ADDENDUM #1

PROJECT: Bridge Classroom Portable at Erma B. Reese ES
Lodi Unified School District

DATE : March 14, 2026

1- ES1.1

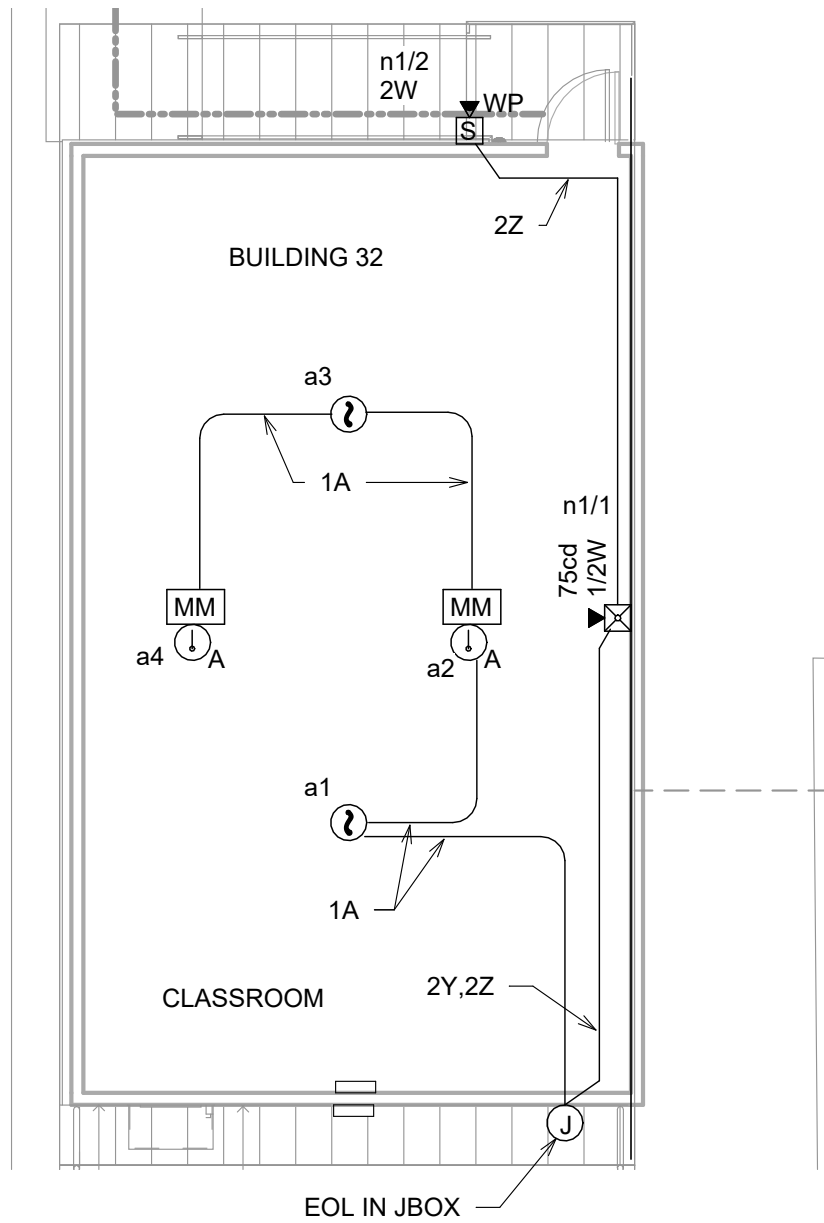
Existing FACP location (building B) revised to correct location (Building A). See revised sheet 1-ES1.1.

The connection pathways for power are shortened to terminate at the sides of the new portable building. See revised sheet 1-ES1.1.

2 SIGNAL PLAN

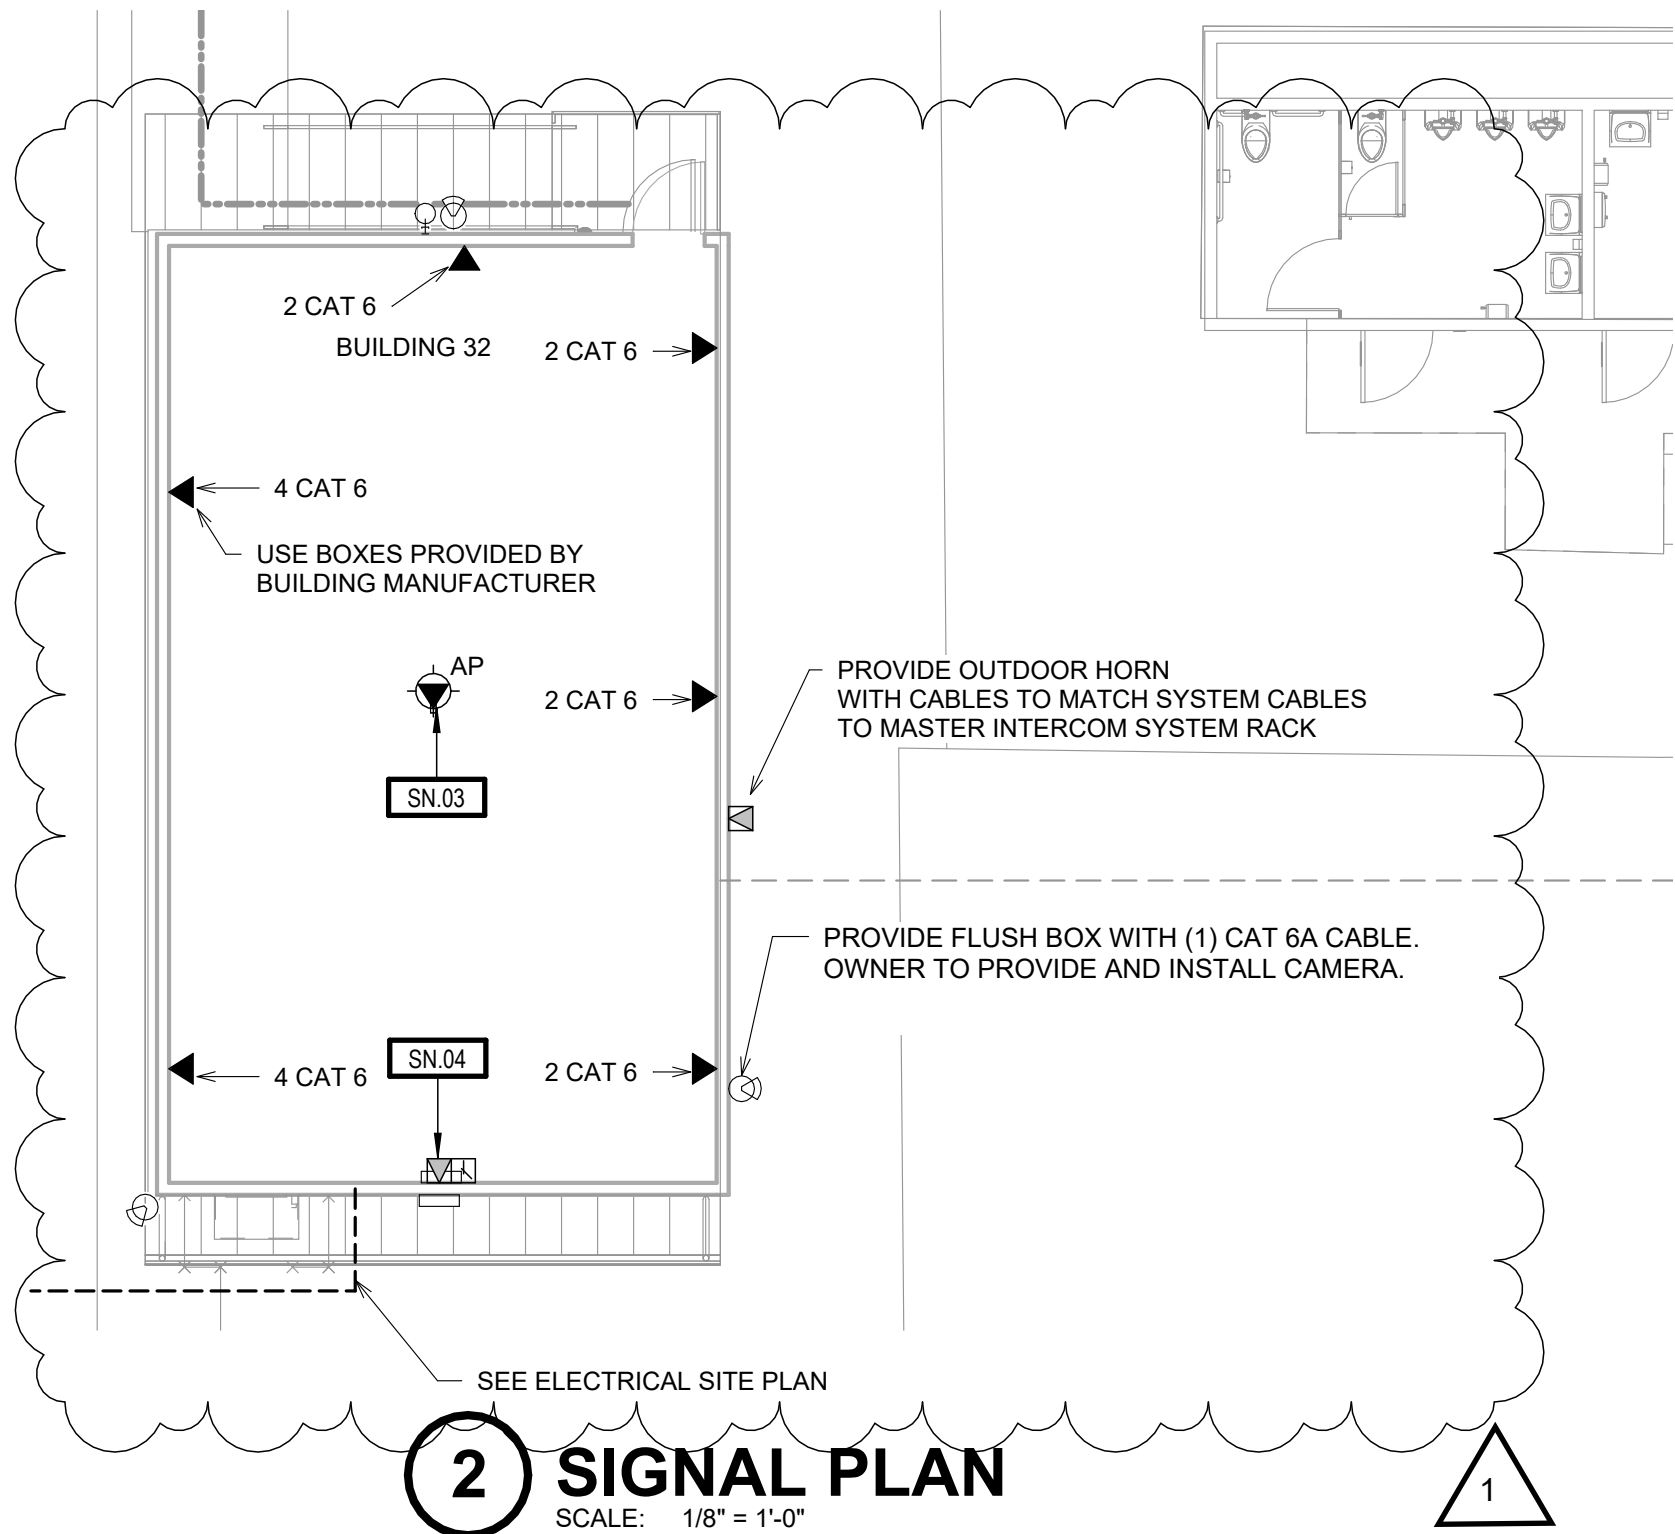
Contractor to provide CAT 6A wiring and 8x8x43r NEMA rated boxes for a new camera. The District will provide and install the security camera. For camera location, refer to revised sheet 1-ES2.1.

Installation of one exterior intercom horn with cabling to match existing system cables as described on revised 1-ES2.1.
